Lewiston Public Library Window Replacement

Bid No. 2022-028

ADDENDUM NO. 2

Membrane Installation:

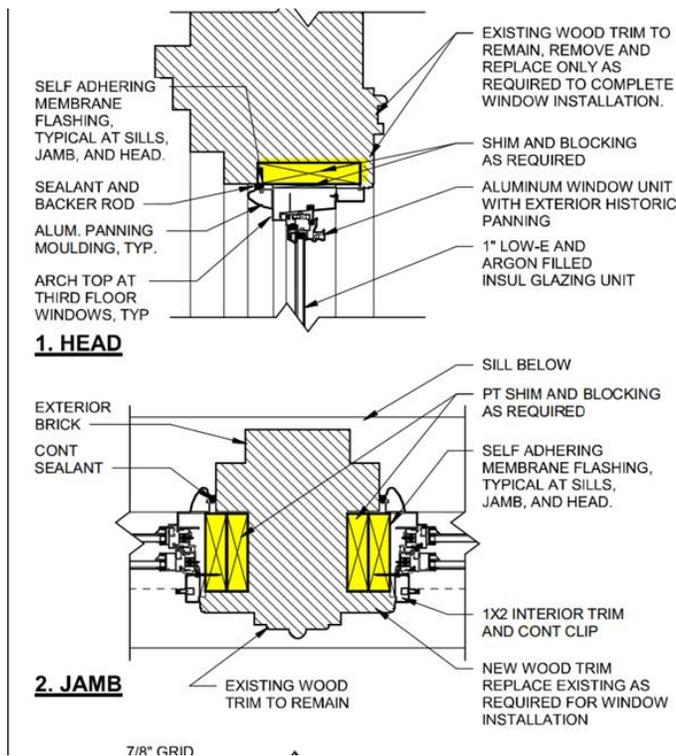
Do you have a specification and detail showing the extent of the membrane flashing? Type, thickness, terminations?

Flashing Membrane: 1. Self-adhered flashing membrane shall be by VaproShield VaproFlashing SA, zero VOC self-adhered water-resistive vapor permeable membrane or equal. Product subject to the following:

- Water Vapor Transfer Rate (ASTM E96-94): <.2g/100 square inches/24hrs.
- Application Temperature: 30 degree F to 180 degree F (-1 degree C to 82 degree C).
- Operating Temperature: -30 degree F to 200 degree F (-34 degree C to 93 degree C).
- Packaging: Rolls packed in convenient dispenser boxes.
- Roll Weight: 6 inches (152 mm) = 22.2 lb (10kg)/roll, 9 inches (229 mm) = 33.3 lb (15 kg)/roll.
- Provide Width for Application Required: 6 inches by 75 feet (152 mm by 23.9 m) (2x4 construction), 9 inches by 75 feet (229 mm by 23.9) (2x6 construction).

- a. Wrap self-adhered flashing membrane into wall openings to cover sill, jambs and head.
- b. Remove release film, align flashing membrane, and apply pressure to ensure positive contact. Roll Lap seams to ensure adhesion. Provide lap seams to shed water.
- c. Install preformed corner flashing membrane into corners over flashing membrane. Secure preformed corners into position with flashing tape and seal to substrate.

d. Follow manufacturer's instructions for installation.
